NEWMAR CORPORATION WARRANTY DEPARTMENT

TECHNICAL SERVICE BULLETIN																	
DATE ISSUED		MODEL YEAR(S) AFFECTED		MODEL(S) AFFECTED		TSB #											
9/11/07		2007		X-Aire FW		317											
BRAND						TYPE											
All	<input type="checkbox"/>	American Star	<input type="checkbox"/>	Mountain Aire	<input type="checkbox"/>	All	<input type="checkbox"/>										
		Dutch Star	<input type="checkbox"/>	Kountry Aire	<input type="checkbox"/>	T T	<input type="checkbox"/>										
X-Aire	<input checked="" type="checkbox"/>	Kountry Star	<input type="checkbox"/>	Essex	<input type="checkbox"/>	F W	<input checked="" type="checkbox"/>										
Scottsdale	<input type="checkbox"/>	Northern Star	<input type="checkbox"/>	London Aire	<input type="checkbox"/>	C A	<input type="checkbox"/>										
						D P	<input type="checkbox"/>										
						D B	<input type="checkbox"/>

Ramp Door Cable (Bracket) Change

Removing Trolley

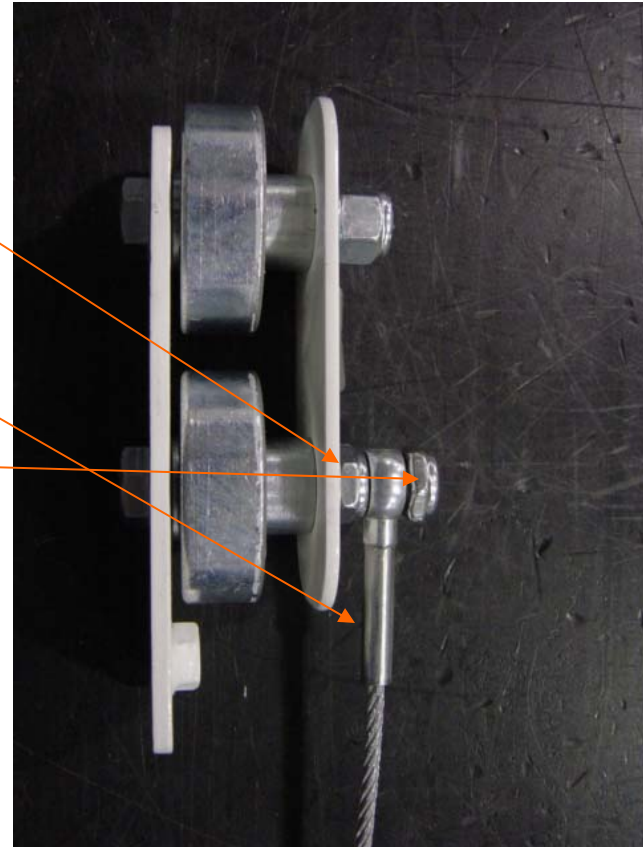
- Step 2
- Remove bolt that attaches the strut to the trolley. A 9/16 socket works best.
- With the bolt removed push the trolley upward to remove it from the column.

Removing old cable

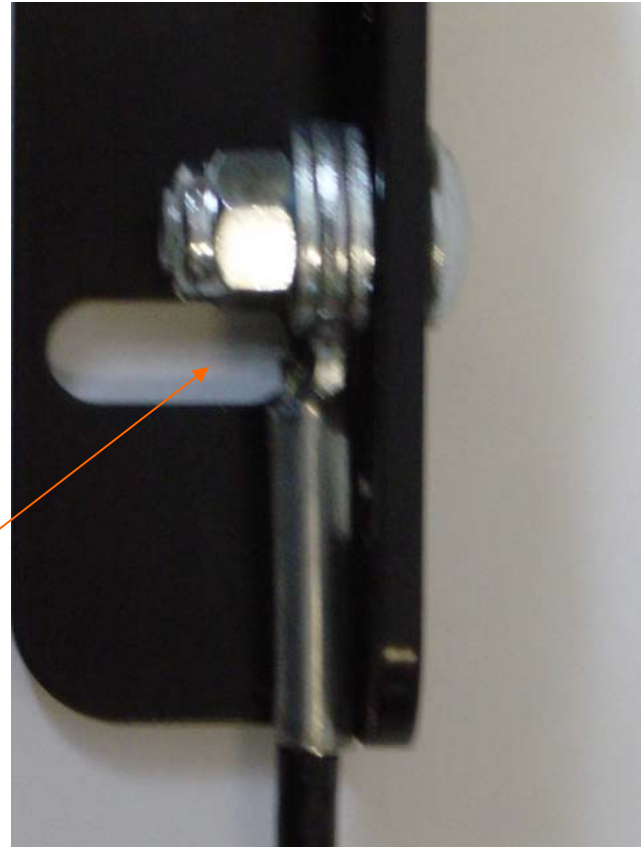
- Step 6
- Carefully unlock and open door. Keep in mind that only one cable is connected and you may need help to open and close the door.
- Remove the nut, cable, and carriage bolt from the bracket mounted on the door.

Installing new cable

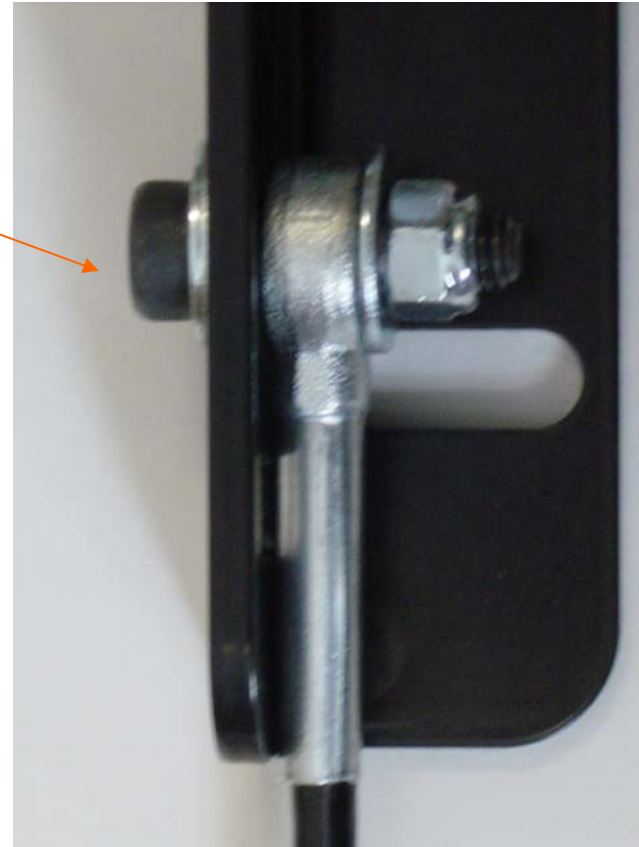
- Step 7
- Using same location on the door bracket install the shoulder bolt, washers, new cable, and nut as shown. (hardware included)
- **CAUTION:** The cable must rotate freely on stud. If cable does not rotate freely adjust nut until it does. Failure to do so will severely diminish the performance of the system and may cause damage to the cable.
